BRUNSWICK STEAM ELECTRIC PLANT, UNIT NOS. 1 AND 2
DOCKET NOS. 50-325 AND 50-324
LICENSE NOS. DPR-71 AND DPR-62

RESPONSE TO REQUEST FOR ADDITIONAL INFORMATION ON CONTAINMENT PURGING

FIGURE 1

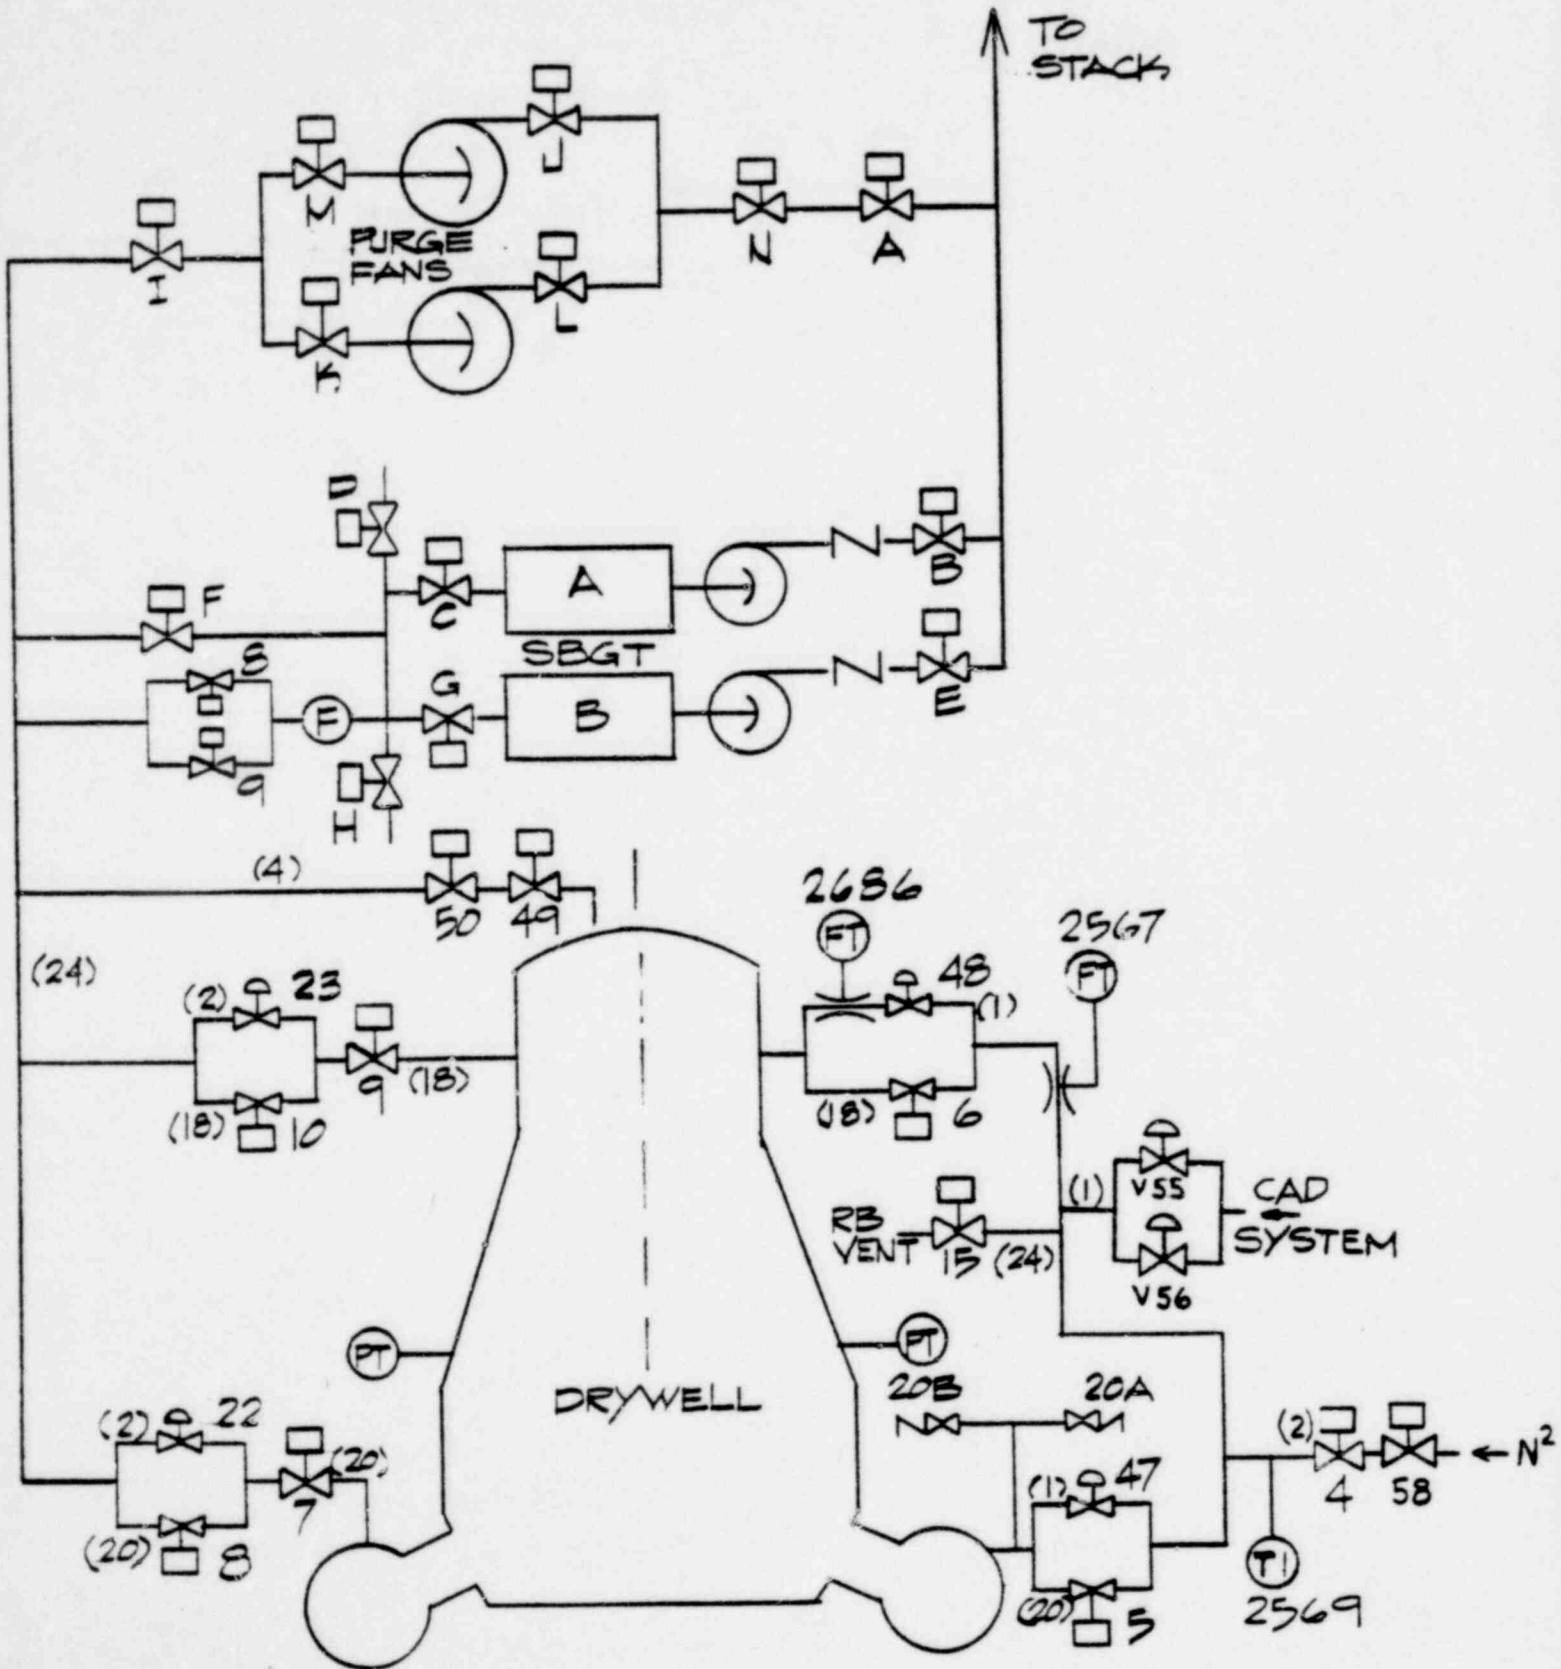
We have completed our review of your letter dated August 23, 1979, and its enclosure which was related to containment purging during normal operation at the Brunswick Steam Electric Plant. This letter is our response to the requests presented in that enclosure. Figure 1 is attached for reference.

- ld. The containment isolation valves used in the CAC System were specified to operate against containment design pressure, 62 psig. In addition, since these are butterfly valves with symmetric areas on either side of the pivot pin, differential pressure does not significantly affect the operability of the valves. The maximum specified allowable leakage rate at 62 psi differential pressure is 2 cc/hr per inch of seat diameter.

A modification is being prepared to correct both the single failure problem and the valve reopening problem mentioned above. This modification will separate the isolation override logic of the two valves in series in each vent path by placing the logic on separate switches. CAC-V7, V9 and V49 isolation override logic will be removed from control switch CAC-CS-2986 and placed on control switch CAC-CS-3452. The possible automatic reopening of the containment valves listed above is being prevented by replacing their two position "open" "close" switches with three position spring-return-to-neutral switches and appropriate holding contacts. A copy of the modification information will be sent to NRC as soon as it is completed.
